Access Compliance Report Public Rights-of-Way (Curb Ramps)

Main Street: CHESNEY_DR Cross Street: FOSTER_RD Location: NE

ADA ID: RPAT211201083653 Ramp Type: Type 1 - Perpendicular Diagonal Initial Pass/Fail: Pass Overall Compliance: No Severity Score: 14

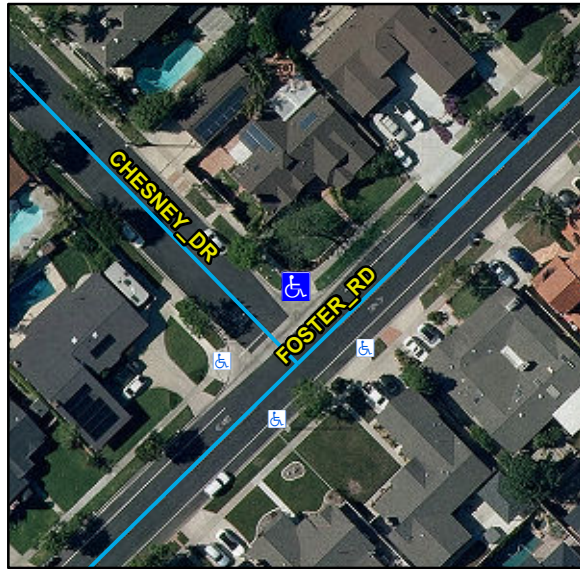
R304.2.2, R204.3, R304.2.1, R304.2.2-Perp, R304.3.2-Para, R305, STD 1115

Remove & Replace Curb Ramp With Two New Directional Ramps or Equivalent.
